TECHNICAL MANUAL
32 AND 33
TELETYPEWRITER SETS
KEYBOARD SEND-RECEIVE (KSR)
RECEIVE-ONLY (RO)
AUTOMATIC SEND-RECEIVE (ASR)

- 1.001 This addendum supplements existing adjustments in Bulletin 273B, Volume 2, Change 5, and applies only to 33TN and 33TX ASR sets.
- 1.002 Adjustments on the following pages augment sections in Bulletin 273B, Volume 2, as follows:

BULLETIN 273B
VOL 2

RESET LEVER SPRING TENSION (See Figure 4)

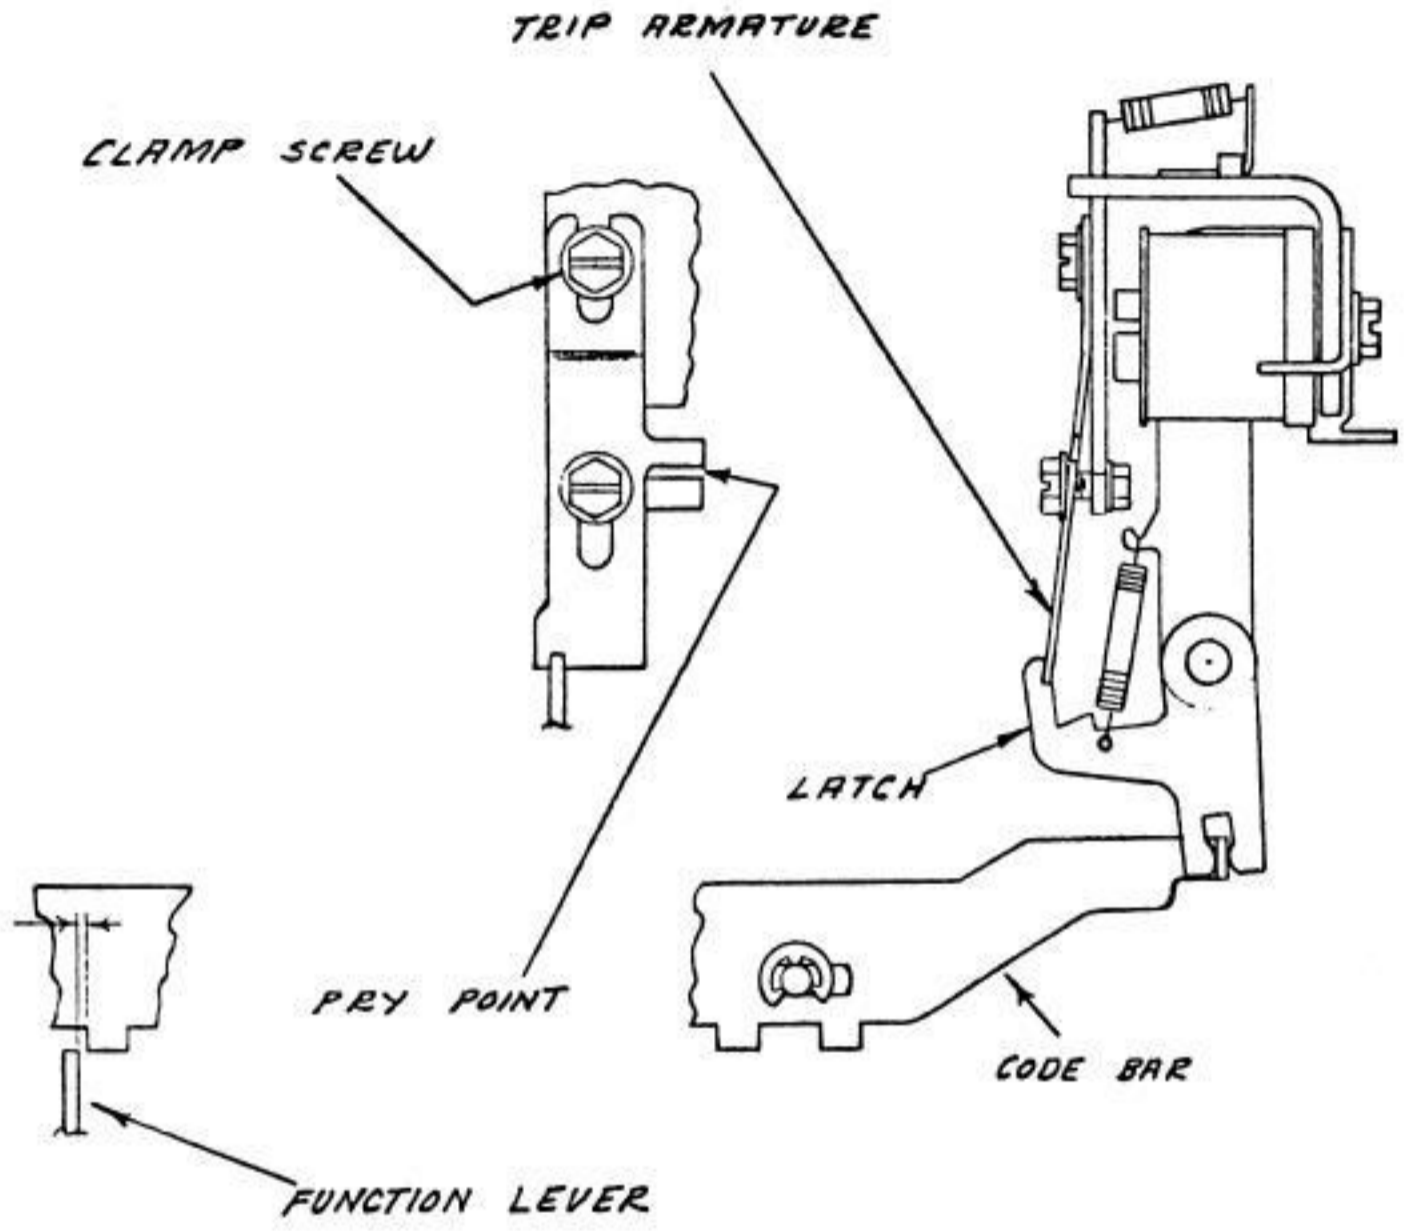
KEYBOARD DRIVE HUB ADJUSTMENT (See Figure 4)

3.001 Requirement: With the play taken up to the right, there shall be 0.060" to 0.070" clearance between the adjusting plate and keyboard reset lever.

Note: There is enough play that reset lever will touch adjusting screw.

3.002 To Adjust: Loosen setscrew and position hub.

KEYBOARD RESET LEVER ADJUSTMENT (See Figure 4)

3.003 Requirement: With the reset solenoid energized, there shall be 0.010" to 0.040" clearance between the keyboard reset lever and the latchlever.

3.004 To Adjust: Loosen clamp adjusting screw and position by pry points.

KEYBOARD CLEAR SWITCH ADJUSTMENT (See Figure 4)

3.005 Requirement: The switch actuator shall be centered in engagement with the keylever (by eye) and there shall be 0.025" to 0.040" clearance between the keylever and actuator in the unoperated condition.

3.006 To Adjust: Loosen bracket mounting screws to meet centering adjustment. Loosen switch mounting screws and position actuator to meet requirement.

KEYBOARD TIMING CONTACT MAGNET ADJUSTMENT (See Figure 4)

3.007 Requirement: There shall be 0.020" to 0.040" clearance between magnet face and reed switch assembly.

3.008 To Adjust: Bend extension lever at form to meet requirement.

KEYBOARD TIMING CONTACT ADJUSTMENT (See Figure 4)

3.009 Requirement: (Preliminary) Position reed switch assembly so that rear edge of assembly is approximately flush with rear edge of bracket.

3.010 Requirement: (Final) With the keyboard reset lever in the latched position, the contact shall be closed; with the keyboard reset lever tripped, the contact shall be open.

3.011 To Adjust: Loosen clamp screw and position switch assembly to meet requirement.

- 5.003 With the reset lever latched, it shall take 9-1/2 to 10-1/2 oz to start the reset lever moving.

TRIP ARMATURE ADJUSTMENT

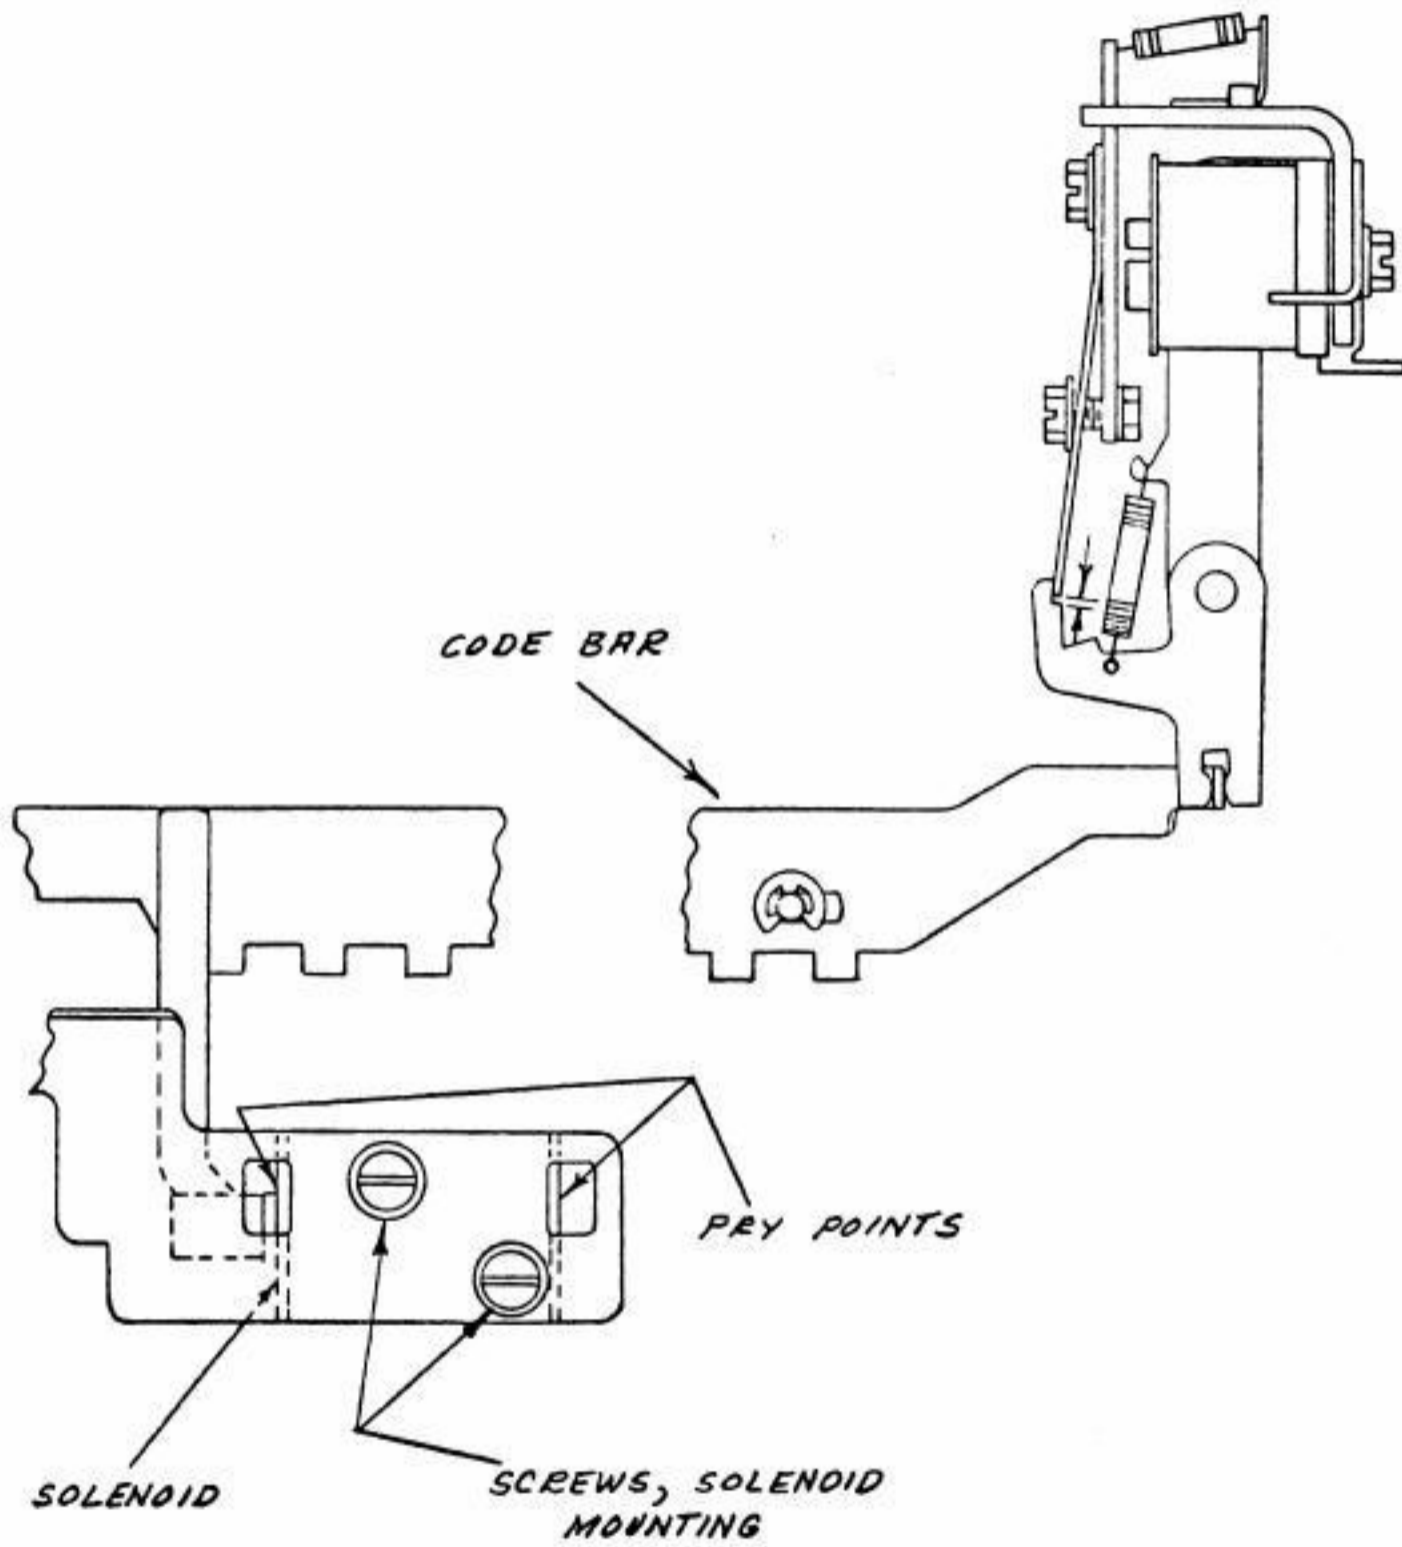
PRINTER "ON" TRIP ARMATURE ADJUSTMENT (See Figure 1)

- 2.001 Requirement: With the codebar moved to the right and latched, there shall be 0.010" to 0.020" clearance between the edge of the no. 4 function lever and the edge of the codebar tine.
- 2.002 To Adjust: Loosen the printer "OFF" solenoid mounting screws and position solenoid to the right to allow codebar unrestricted motion. Loosen armature clamp screw and adjust length of armature by means of pry points.

SOLENOID BRACKET ADJUSTMENT

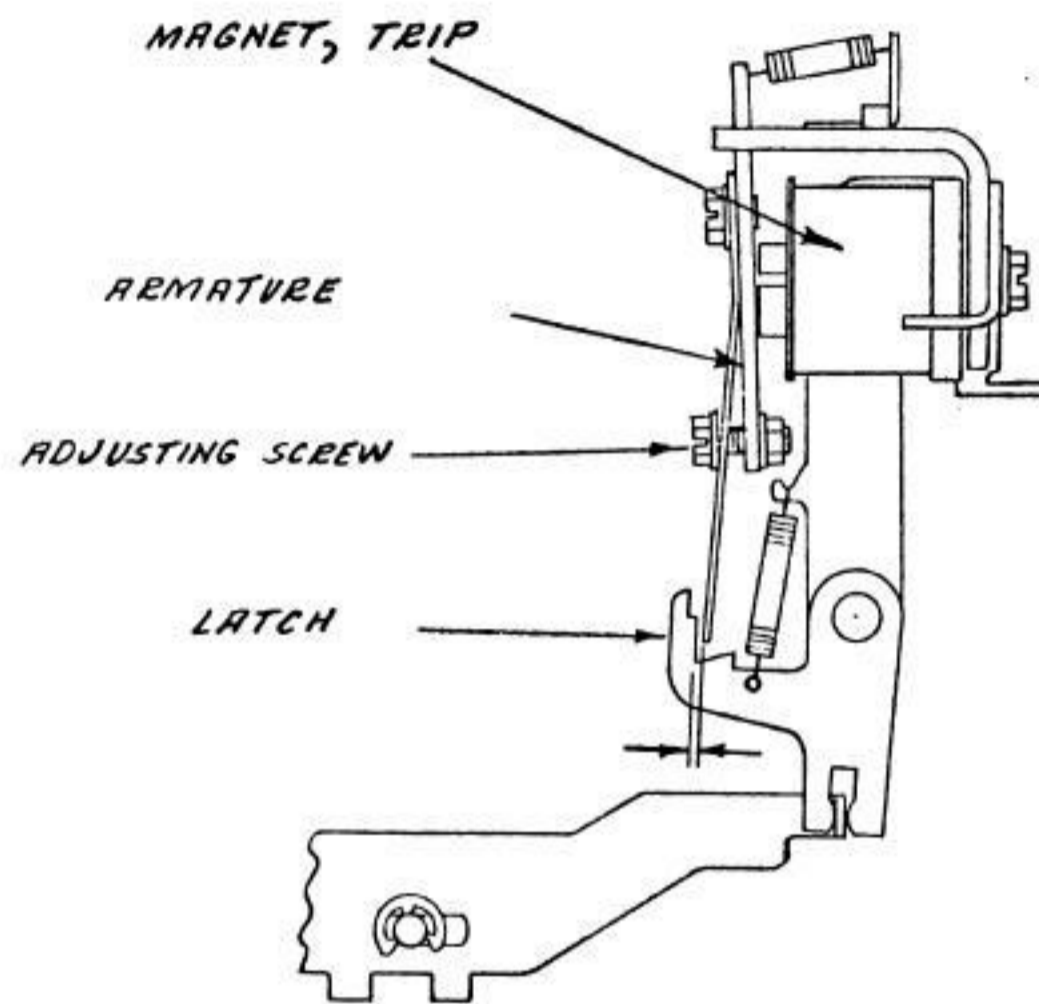
PRINTER "OFF" SOLENOID BRACKET ADJUSTMENT (See Figure 2)

2.003 Requirement: With the solenoid held electrically energized or with the plunger held mechanically seated, there shall be 0.006" to 0.012" clearance between the end of the trip armature and the latch surface.

2.004 To Adjust: Loosen the solenoid mounting screws and position solenoid body by means of pry points.

TRIP MAGNET OVERTRAVEL ADJUSTMENT

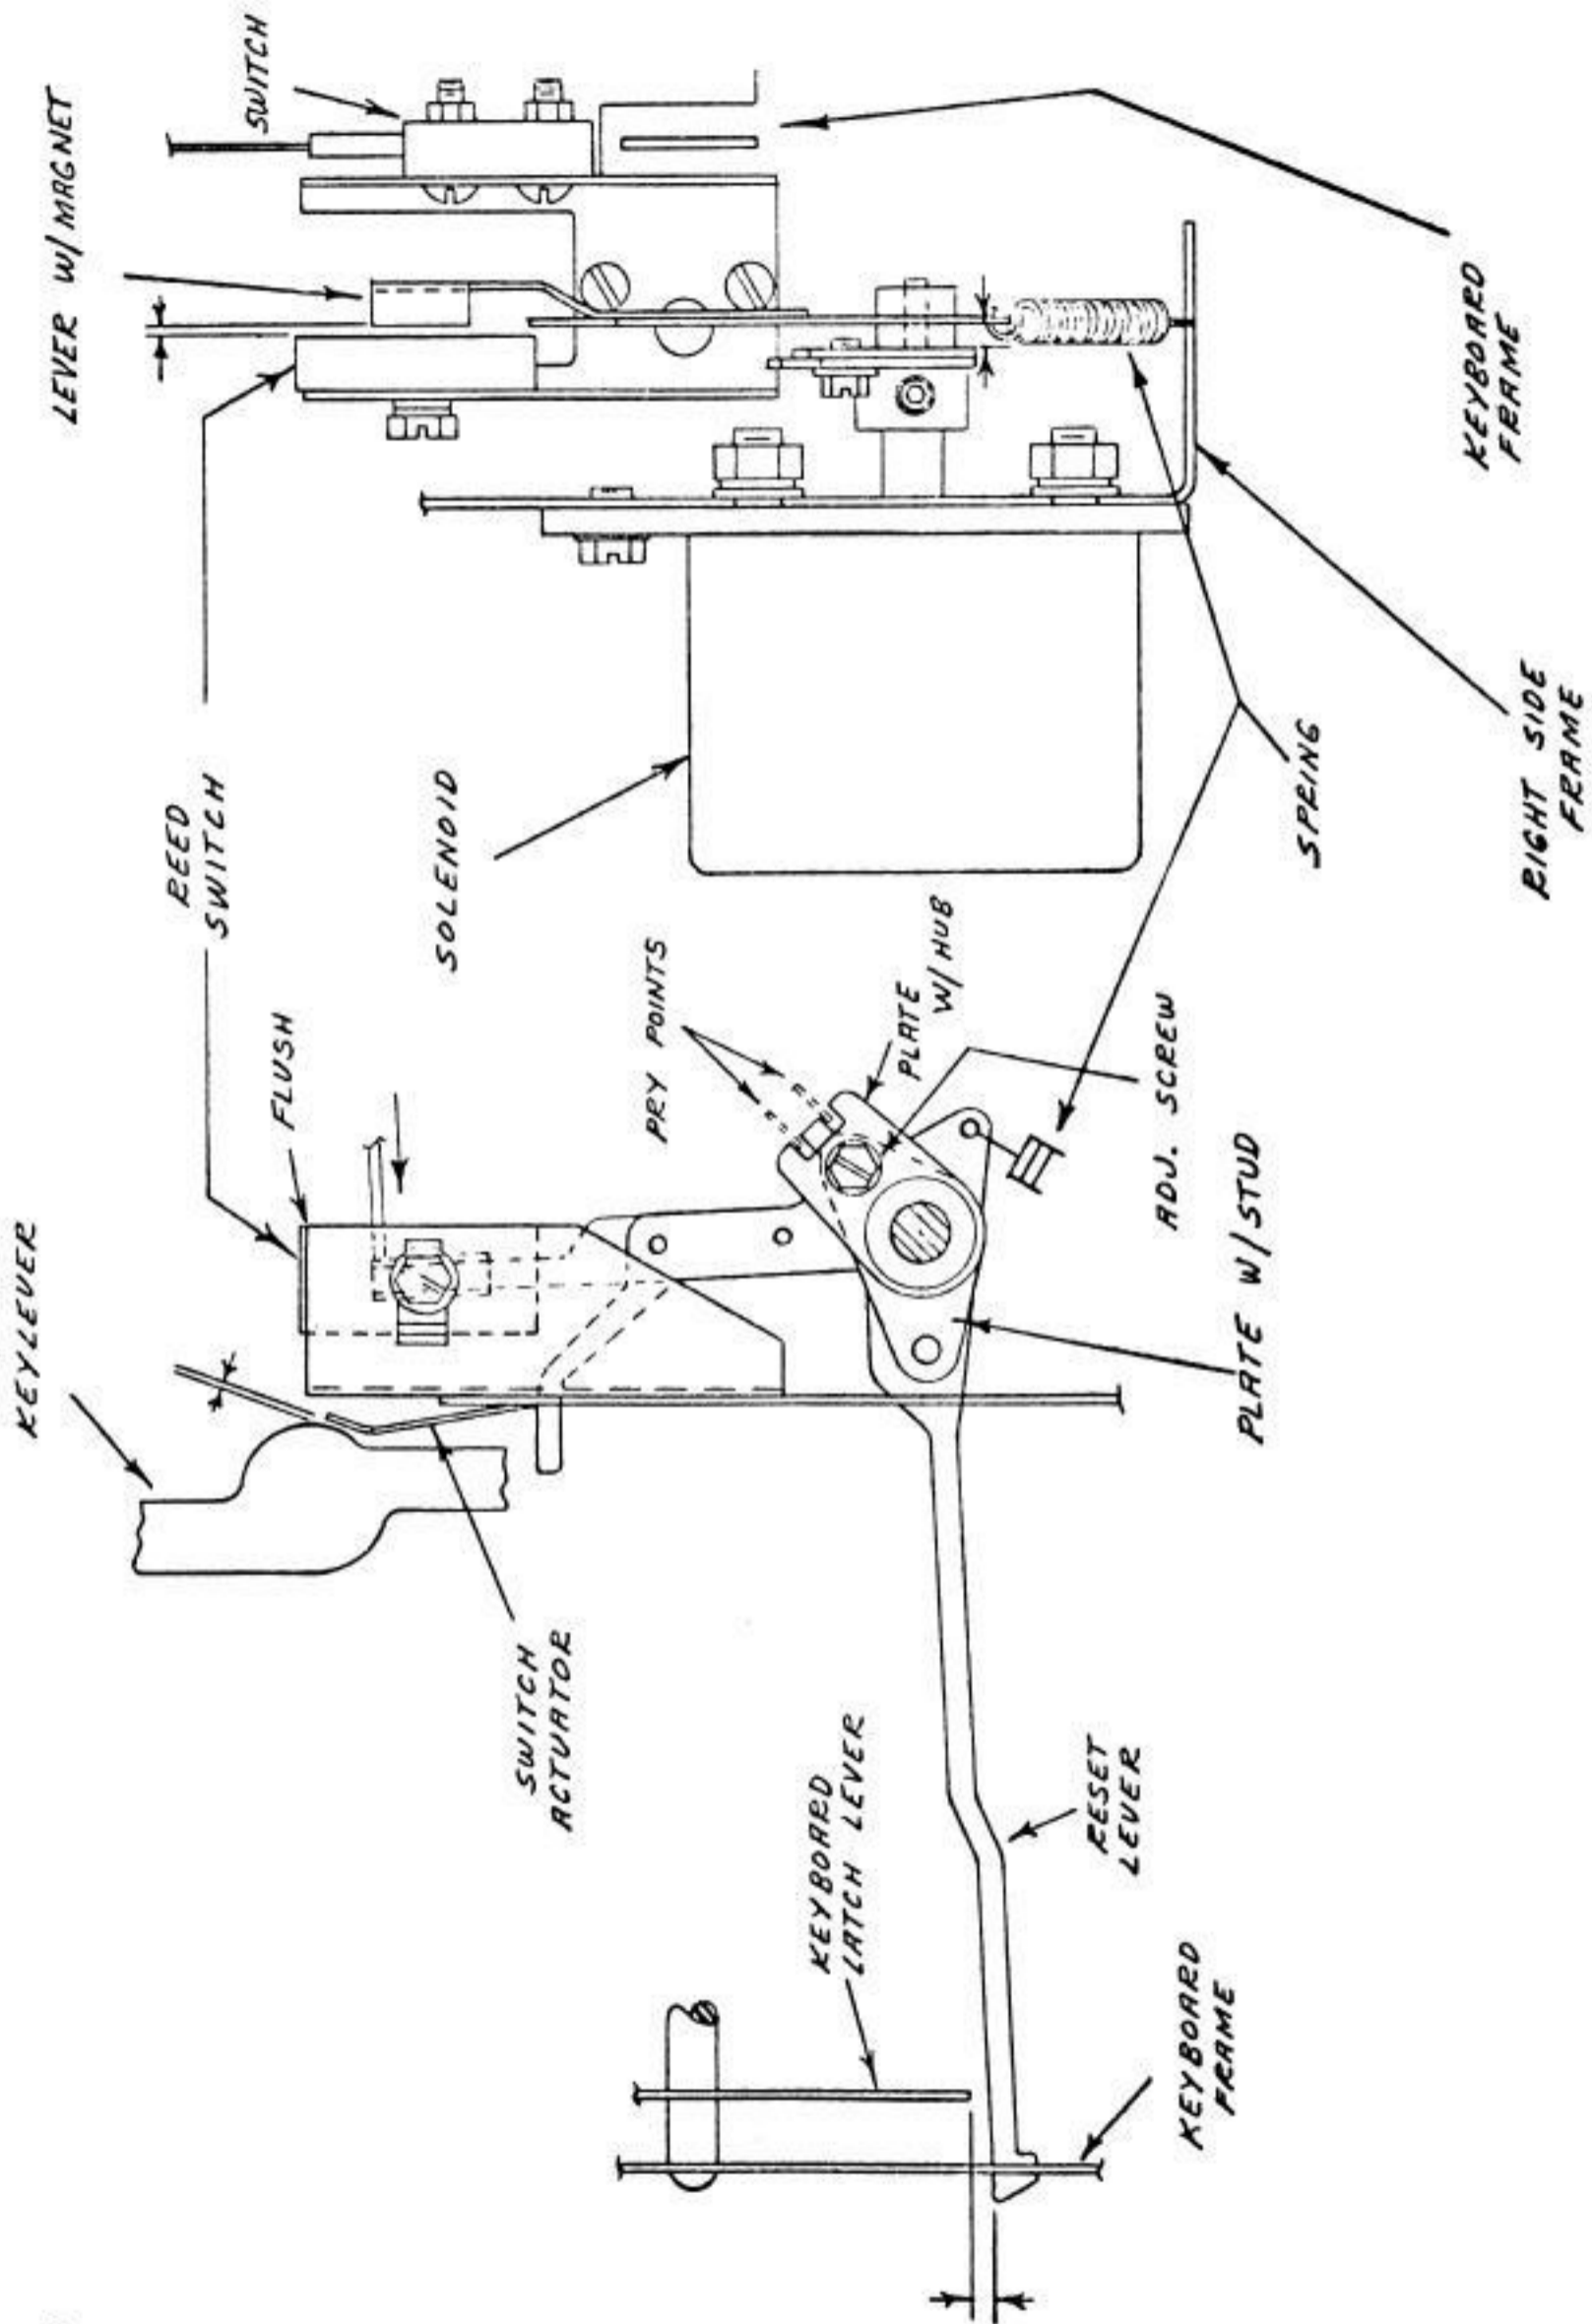
PRINTER "ON" TRIP MAGNET OVERTRAVEL ADJUSTMENT (See Figure 3)

2.005 Requirement: With the armature held against the core, there shall be 0.010" to 0.015" clearance between the armature and latch.

2.006 To Adjust: Loosen clamp nut and adjust overtravel by turning adjusting screw.

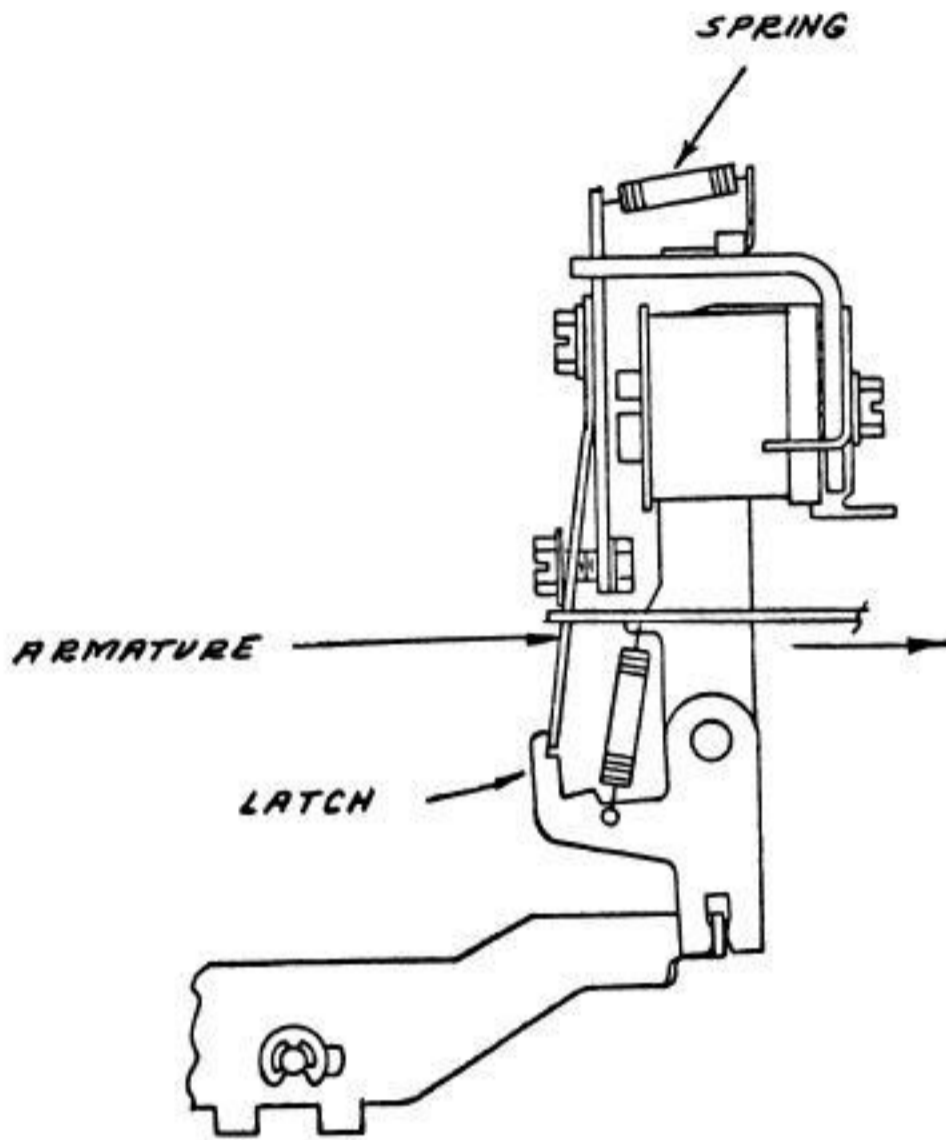
TIMING CONTACT ADJUSTMENTS (See Figure 5)

4.001 Requirement: (Preliminary) Position both switches so that they are in the center of their adjustment slots.

4.002 Requirement: (Final) With the sensing pins fully down, the reset switch (front) shall be closed and the busy switch (rear) shall be open. With the sensing pins fully up in the energized position, the switches shall transfer.

4.003 To Adjust: Loosen adjusting screws and move switches up or down to meet requirement.
